VAN'S AIRCRAFT
TOTAL PERFORMANCE

SERVICE BULLETIN 00036 - REV 3

Subject: Cracking in horizontal stabilizer rear spar at outboard elevator hinge brackets

Affected Models: RV-3, RV-4, RV-6/6A, RV-9/9A, RV-10, RV-14/14A

FIGURE 1: EXAMPLE 1 - CRACK LOCATIONS – AFT SIDE OF SPAR

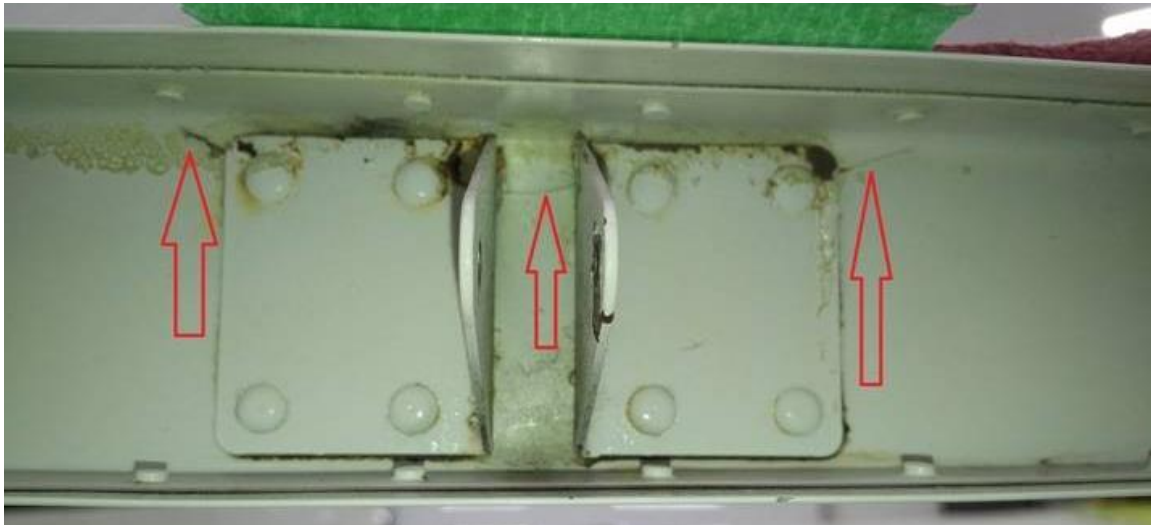
Van's Aircraft has received reports of cracks forming in the outboard elevator hinge bracket areas of the horizontal stabilizer rear spar. See Figures 1 through 4 below for visual examples of cracks.

Formation of these cracks is caused by loads from the elevator hinge pushing and pulling on the web of the rear spar. This has been observed and reported on multiple RV-3, RV-4, RV-6, RV-7 and RV-8 aircraft, in many cases where aerobatics were performed and the airframe total times were near 2,000 hours, although cracks have since been reported on aircraft with a variety of total times and operations.

Step 1: Inspect the outboard elevator hinge bracket area on the forward surface of the horizontal stabilizer rear spar for cracks. Examples of cracks are shown in Figures 1 through 4.

Cracks meeting the following conditions mandate replacement of the spar:

- Cracks that have propagated into the bend of the spar
- Cracks that span from one rivet hole to another rivet hole

Cracks that do not meet the spar replacement criteria must be stop-drilled using a #40 hole at the extreme end of the crack. This hole must be at least .098 from the edge of any rivet hole and may not extend into the bend of the spar. If you cannot meet these minimum distance requirements when drilling, replace the rear spar.

FIGURE 5: RIVET CALLOUTS AND REAR SPAR AFT VIEW

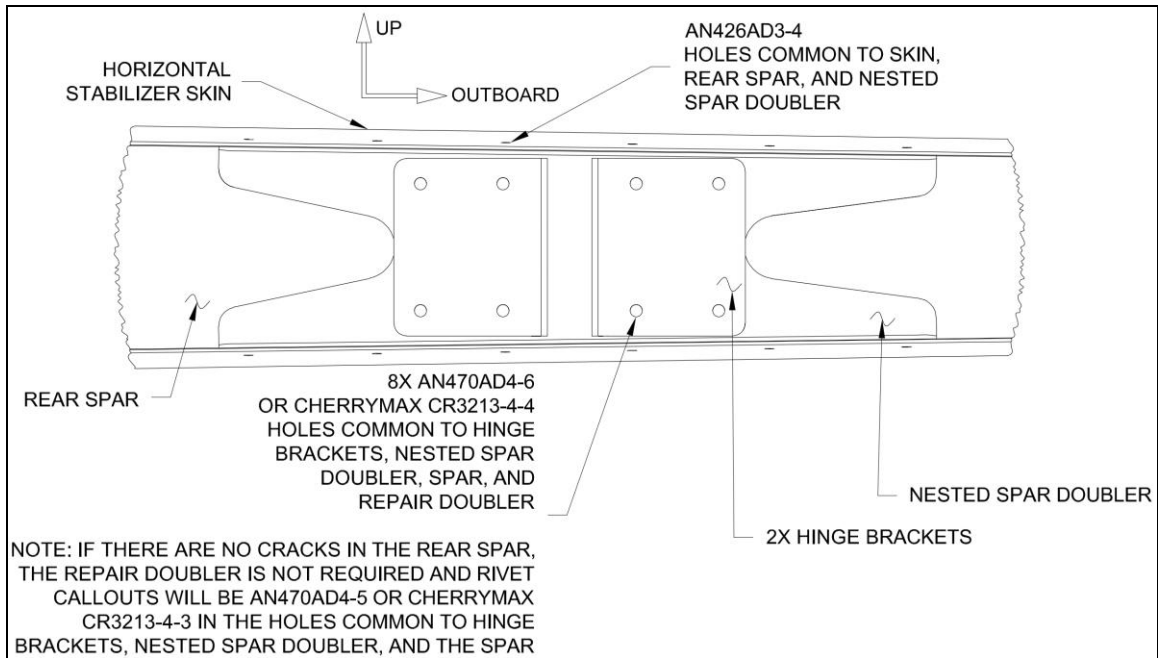
Step 8 (RV-3): Clamp the nested spar doubler into the appropriate location in the spar. See Figure 5 for an example installation.

Step 9 (RV-3): Match drill the holes common to the skin and rear spar into the nested spar doubler. The doubler should capture at least six rivets from the skin and rear spar in each flange of the doubler. The doubler must be at least 7.00 in length. See Figure 5 for an example installation and Figure 12 for final trimming guidelines.

Step 43 (RV-6PP/7/8): Cleco the HS-00717A Outboard Elevator Hinge Brackets to the rear spar and match drill the holes common to the rear spar, nested spar doubler, and repair doubler (if required). See Figure 5.

Step 49: Cleco the hinge brackets to the rear spar and nested spar doubler. See Figure 5 and Figure 6 for reference.

Step 51: Rivet the holes common to the hinge brackets, nested spar doubler, rear spar, and repair doubler (if required). See Figures 5 and 6.

Step 52: Rivet the holes common to the skins, rear spar, and nested spar doubler. See Figure 5 for rivet callouts.

FIGURE 6: REAR SPAR SECTION VIEW

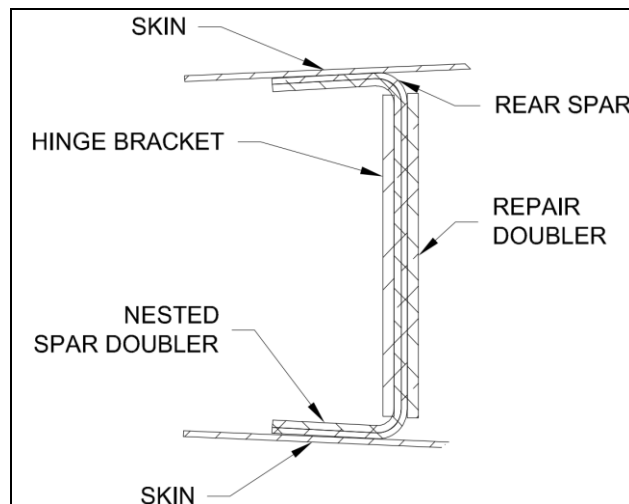
NOTE: See Figure 6 for a section view of the assembly.

Step 50 (If cracks are present): Cleco the repair doubler to the forward side of the rear spar. See Figure 6 for reference.

FIGURE 7: MATCH DRILLING PIVOT BOLT HOLE

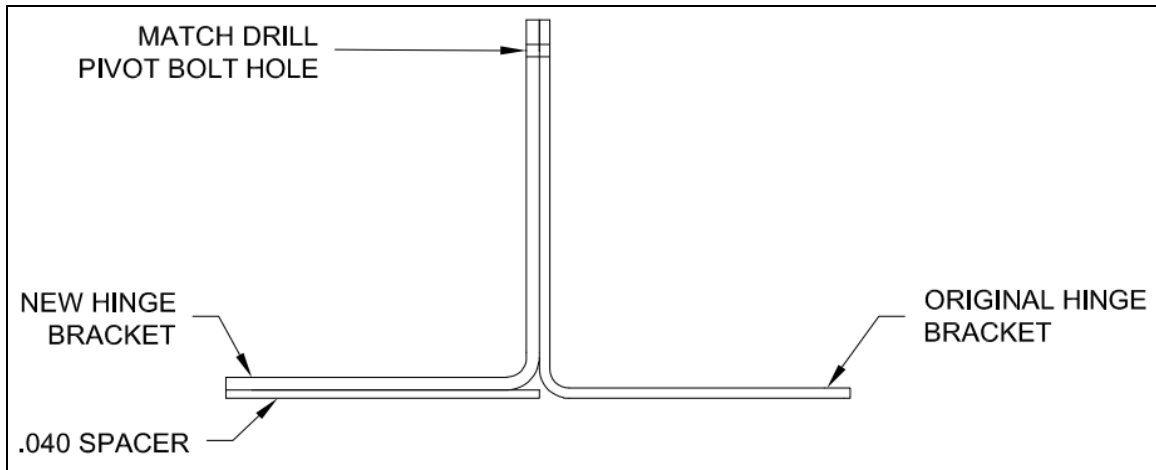
Step 15 (RV-3): Place a new hinge bracket and a .040 thick spacer, that is fabricated to fit the same footprint as the hinge bracket, onto a flat surface. See Figure 7.

Step 16 (RV-3): Clamp the triangular flange of the new hinge bracket and sheet assembly to a corresponding original hinge bracket. See Figure 7.

Step 17 (RV-3): Match drill the hole for the AN3 pivot bolt that goes through the elevator rod end. See Figure 7.

FIGURE 9: EXAMPLE HS-00718B REPAIR DOUBLER

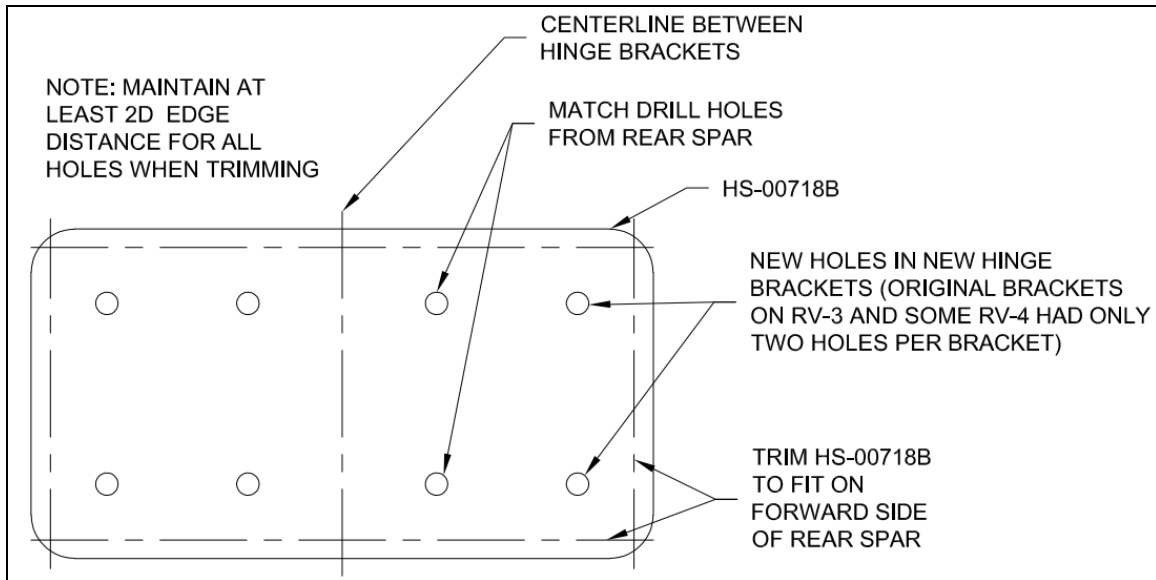
Step 7 (RV-3 – If cracks are present): Fabricate a repair doubler from .063 2024-T3 (or trim a HS-00718B Repair Doubler) to fit the forward side of the rear spar captures all holes from the hinge brackets. See Figure 9 for an example.

Step 19 (RV-4 – If cracks are present): Fabricate a repair doubler from .063 2024-T3 or trim a HS-00718B Repair Doubler to fit the forward side of the rear spar. See Figure 9 for an example.

FIGURE 10: EXAMPLE NESTED SPAR DOUBLER FLAT PATTERN

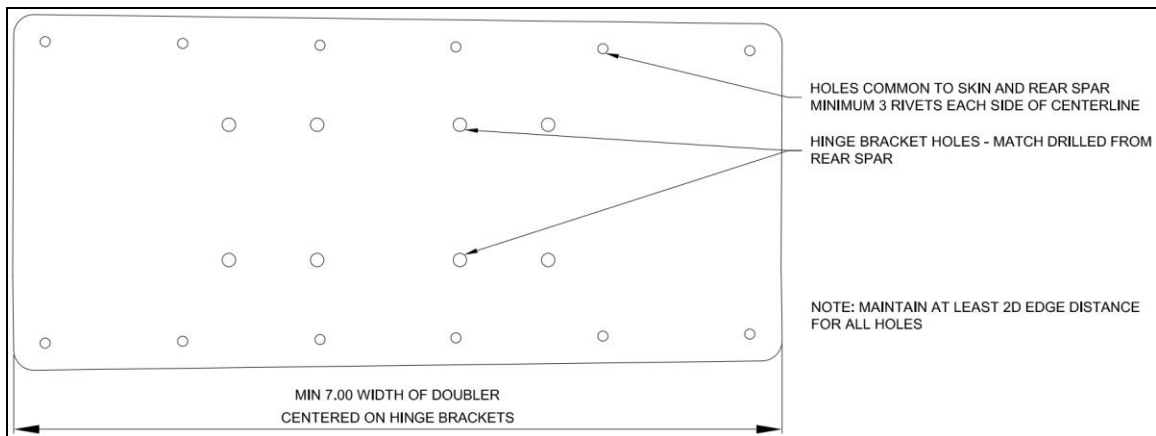
Step 5 (RV-3): Fabricate a bent doubler from HS-00316 Nested Spar Doubler Blank or from .040 2024-T3 that will nest into the rear spar at the outboard hinge brackets. The doubler should be centered on the hinge brackets location.

See Figure 10 for an example flat pattern. This example shows holes that will be in the doubler when it is ready for installation.

FIGURE 11: BEND PROFILE – NESTED SPAR DOUBLER

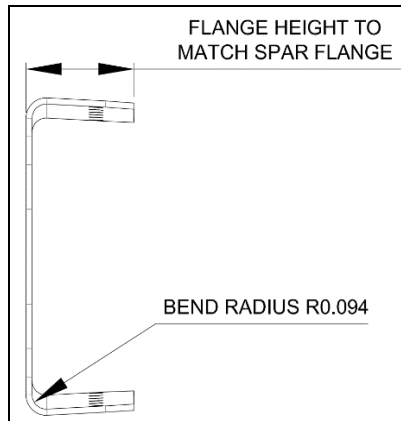
See Figure 11 for bending guidelines.

FIGURE 12: NESTED SPAR DOUBLER TRIM GUIDELINES

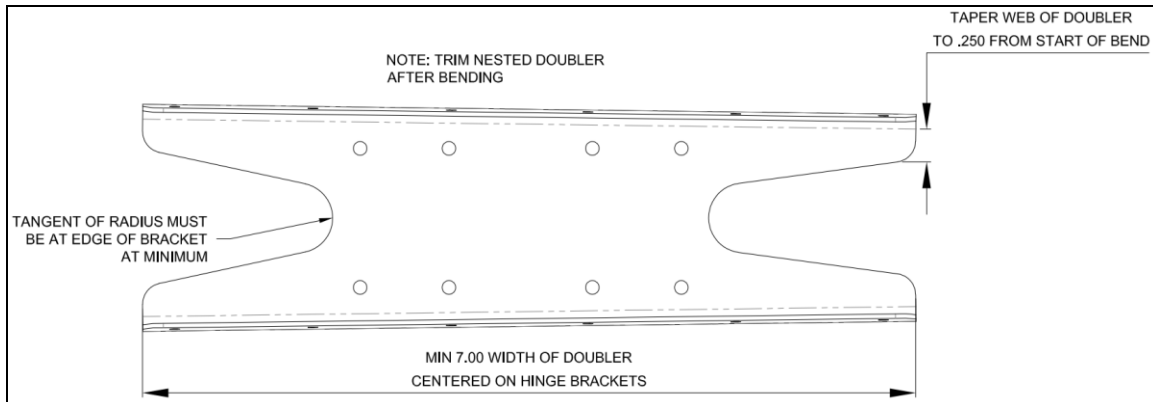
See Figure 12 for trimming guidelines. Trim after bending. The minimum length of the doubler is 7.00. The doubler must also capture at least three rivets on each side of outboard hinge brackets.

Step 22 (RV-4): Trim the nested spar doubler. The holes in the flanges of the nested spar doubler will drive the total length of the doubler, but it must be 7.00 in length at a minimum. See Figure 12 for trimming guidelines.

FIGURE 13: HINGE BRACKET FLAT PATTERN GUIDELINES

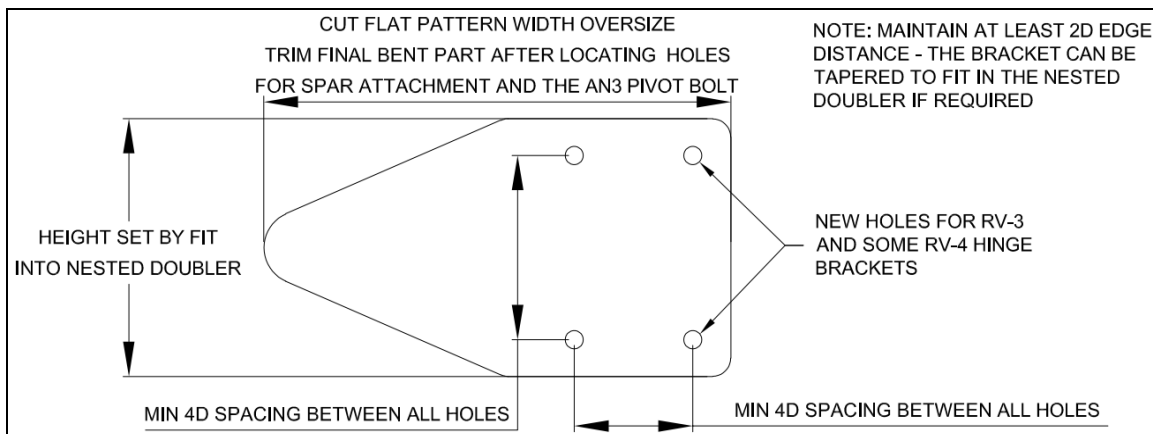
Step 6 (RV-3): Fabricate outboard elevator hinge brackets from .063 4130 Condition N Steel. See Figures 13 and 14 for guidelines.

Step 13 (RV-3): Drill the holes common to the hinge brackets and the rear spar in the new outboard elevator hinge brackets using the original hinge brackets that were removed from the rear spar as a template. Reference Figure 13.

Step 14 (RV-3): Match drill the two new holes in the hinge brackets to the nested spar doubler, rear spar, and repair doubler (if required). Reference Figure 13.

FIGURE 15: TOOLING HOLE

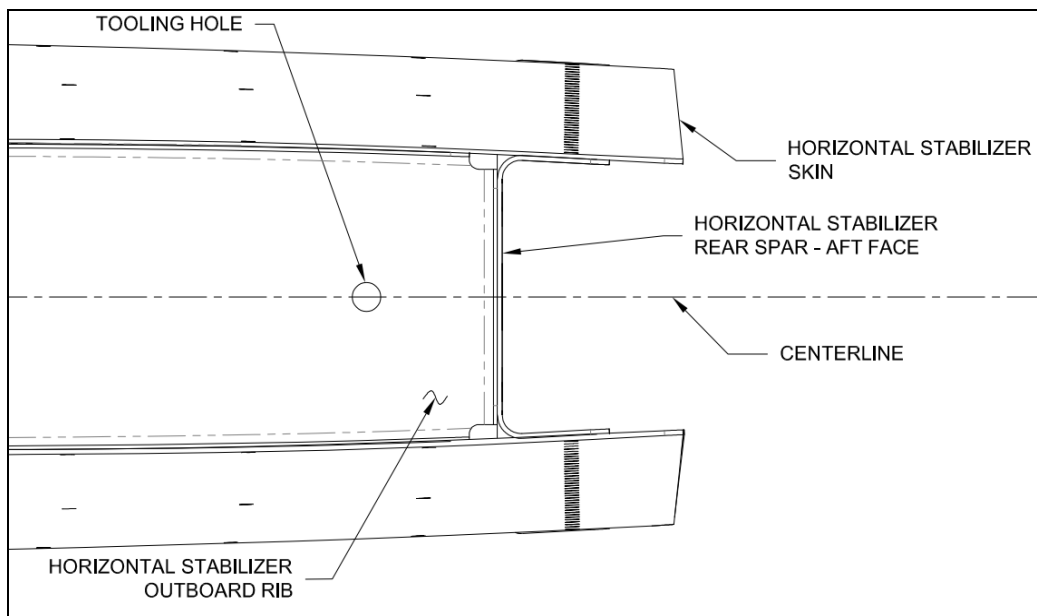
For RV-3/4/6/7/8 aircraft, the aft tooling hole in the horizontal stabilizer outboard rib can be enlarged to 7/16 to accommodate a borescope for inspection of the forward side of the rear spar. If no tooling hole is present, a hole no larger than 7/16 can be added to the outboard stabilizer rib located on the centerline of the rib 1.00 forward of the aft face of the spar. Refer to Figure 15.
